DOCKET ITEM # 9

## ***Master Plan Amendment # 2013 - 0007***

<b>Issue:</b> Public hearing and consideration of a request for an amendment to the Eisenhower East Design Guidelines in the Eisenhower East Small Area Plan chapter of the Master Plan to revise the required sidewalk materials.	Planning Commission Hearing:	December 3, 2013
	City Council Hearing:	December 14, 2013
<b>Staff:</b> Jeffrey Farner, Deputy Director Department of Planning & Zoning <a href="mailto:jeffrey.farner@alexandriava.gov">jeffrey.farner@alexandriava.gov</a>

**FIGURE 1**  
**SIDEWALK MATERIALS - BRICK/CONCRETE**

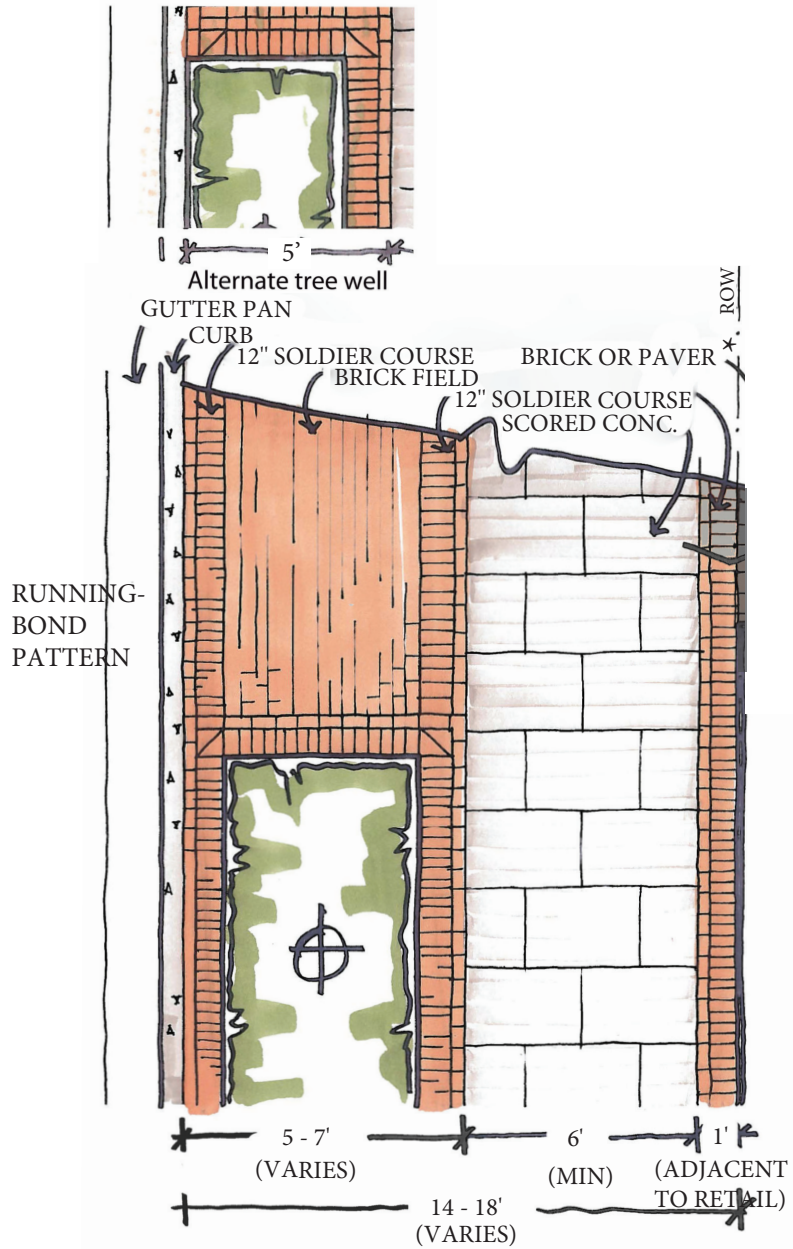
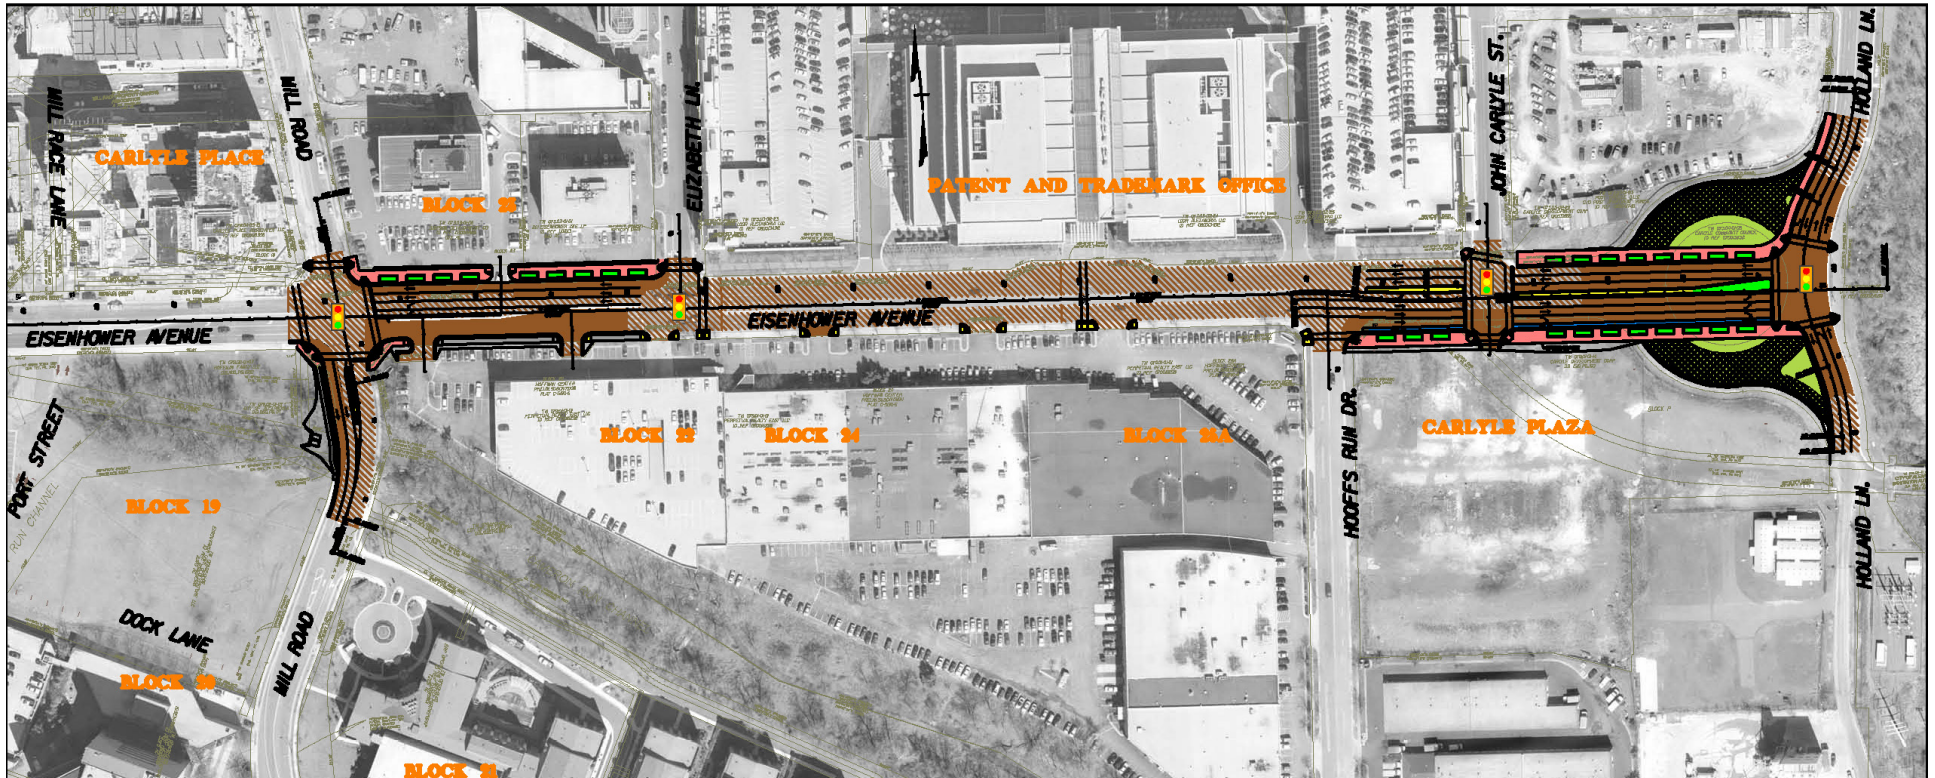
The Eisenhower East Design Guidelines pg. 44 state “*All sidewalks on A and B streets shall be 4” x 8” red brick, laid in accordance with City of Alexandria Standards.* Staff is recommending that the required sidewalk material be revised to be a combination of brick and concrete (Figure 1). The two blocks surrounded by brick sidewalks, staff is recommending the continuation of brick sidewalks. (Figure 3)

Staff is recommending approval of the brick and concrete sidewalks because this approach balances some of the maintenance and accessibility concerns that have been raised by members of the community and City Council regarding brick sidewalks. The proposed sidewalk materials (Figure 1) provide a balance of the functionality of concrete with the aesthetic, color and texture benefits of brick. In addition, as depicted in Figure 3, the location of brick sidewalks (Carlyle and around the Metrorail station) are distinct zones, while the brick and concrete sidewalks will also be located within distinct zones. This approach will ensure that there is coordination of the sidewalks and streetscape within Eisenhower East.

1. Page 44 of the Eisenhower East Design Guidelines shall be revised as follows:  
*“All sidewalks on A ~~and~~ B and C streets shall be a combination of brick and concrete sidewalks 4” x 8” red brick, laid in accordance with City of Alexandria Standards. The Mill Road sidewalk for Block 23 and the sidewalks for Block 20 shall be City Standard brick sidewalks.”* (P&Z) (T&ES)
2. The Eisenhower East Design Guidelines shall be amended including all applicable graphics, images to implement the brick and concrete sidewalks, required herein. The plan view as generally depicted in Figure 1 shall be incorporated as part of the Eisenhower East Design Guidelines. (P&Z) (T&ES)

*All sidewalks on A, B and C streets shall be a combination of brick and concrete sidewalks, laid in accordance with City of Alexandria Standards. The Mill Road sidewalk for Block 23 and the sidewalks for Block 20 shall be City Standard brick sidewalks.*

**FIGURE 3  
EISENHOWER EAST DEVELOPMENT BLOCKS  
AND SIDEWALK MATERIALS**

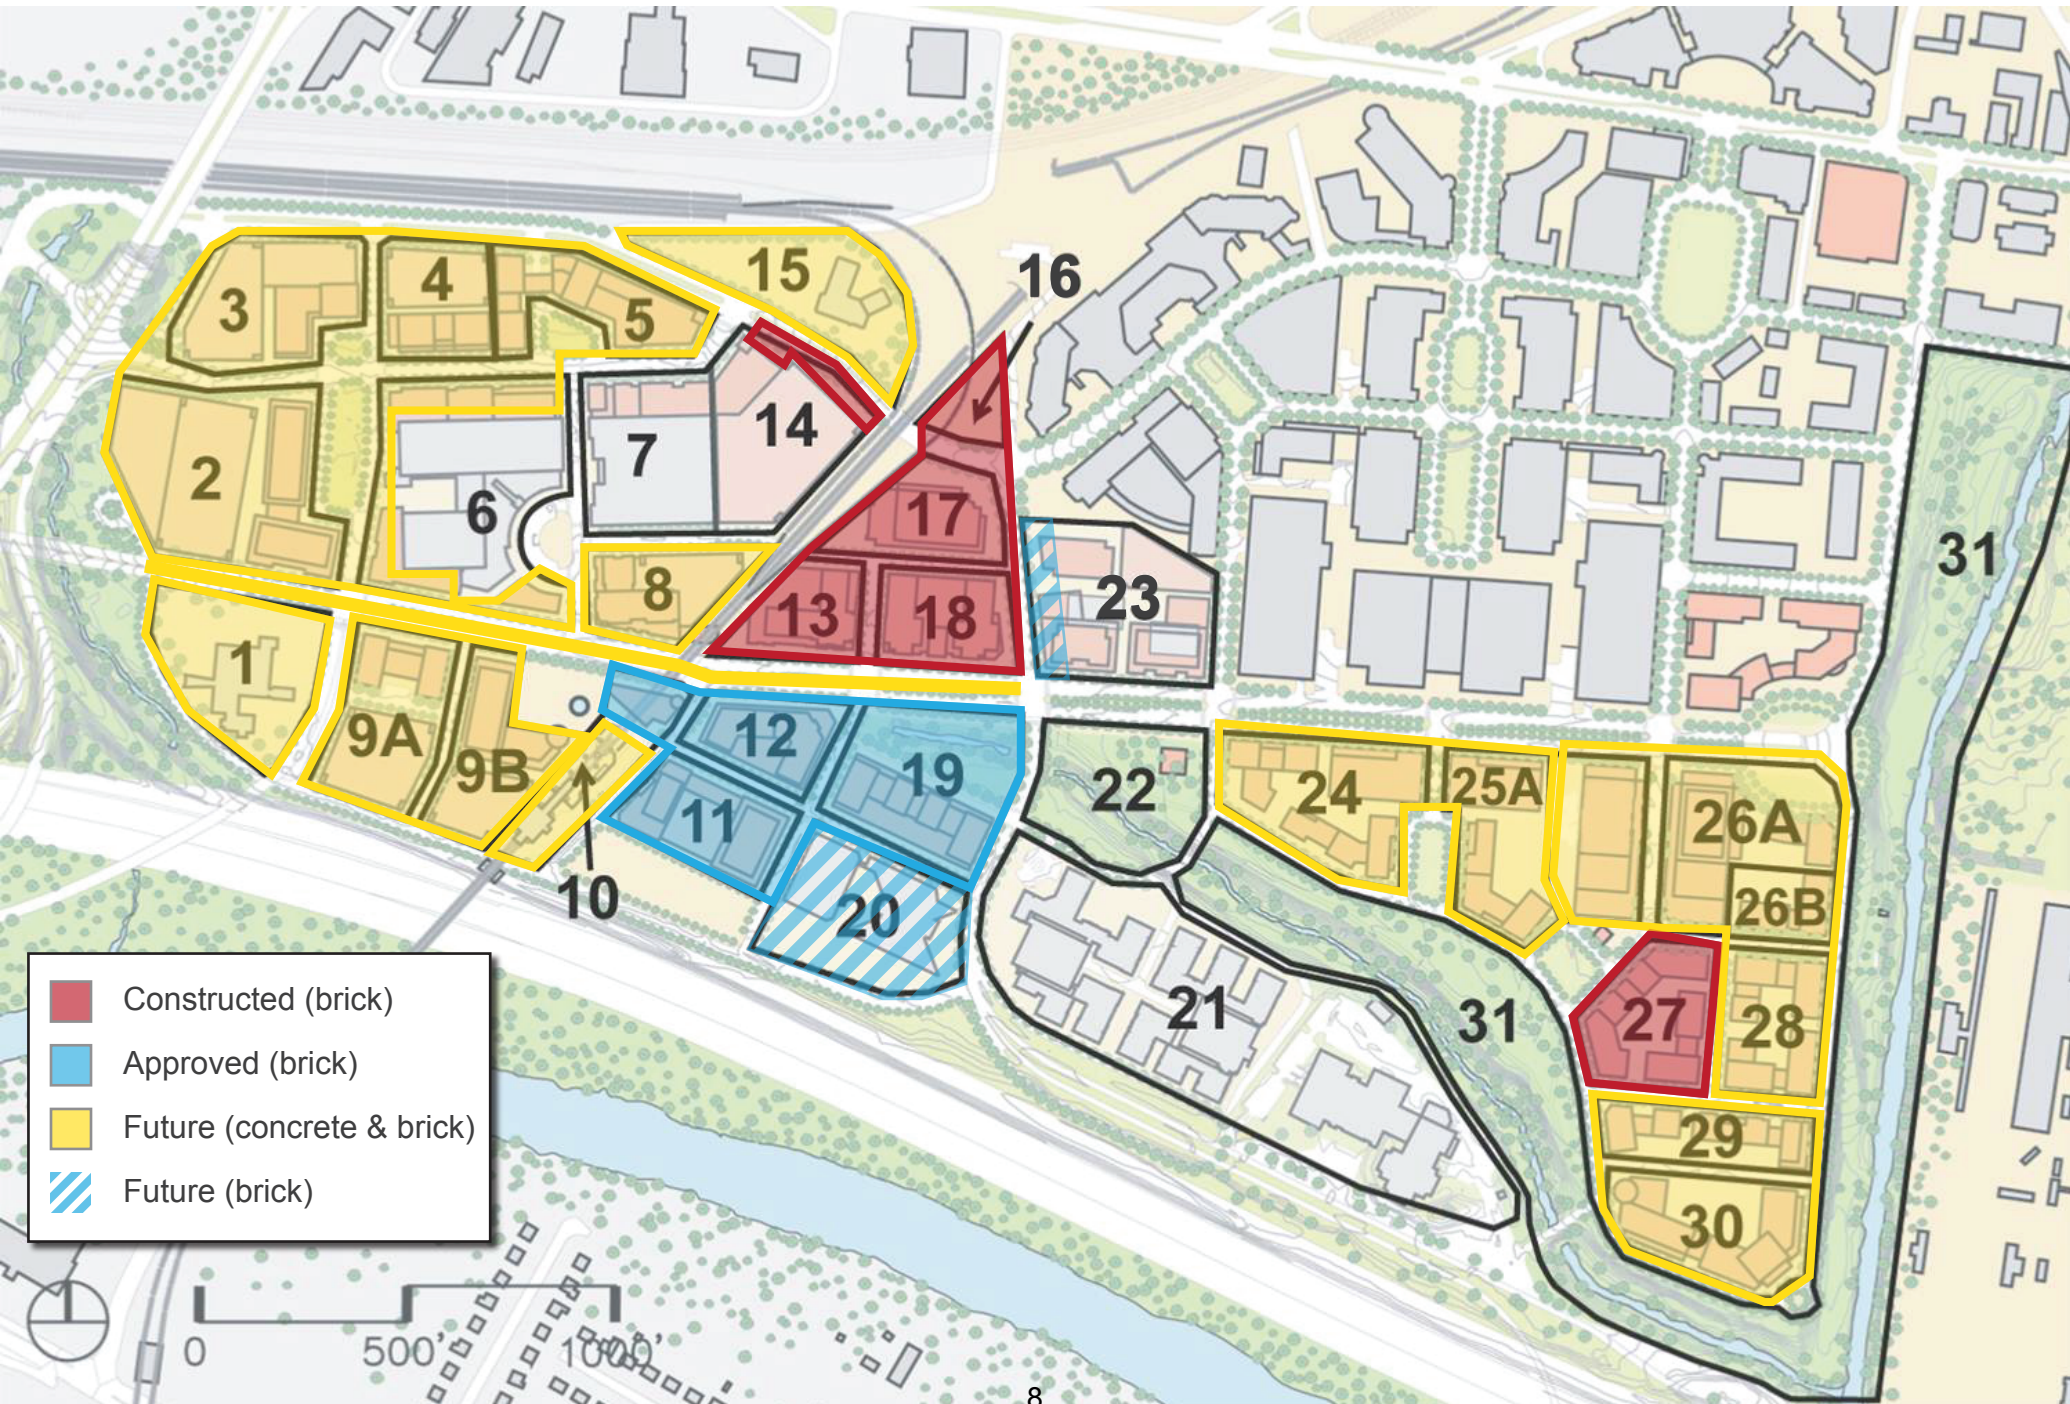
There are two blocks which have received approval for brick sidewalks (Figure 3), adjacent to Eisenhower Avenue. For block 8, a condition requires the construction of brick or a different material if required by the City. For block 12, the Applicant has indicated that they are willing to construct the combination of brick and concrete sidewalk proposed as part of this amendment.

For these blocks because they are surrounded by brick sidewalks, staff is recommending the continuation of brick sidewalks within these blocks. (Figure 3)
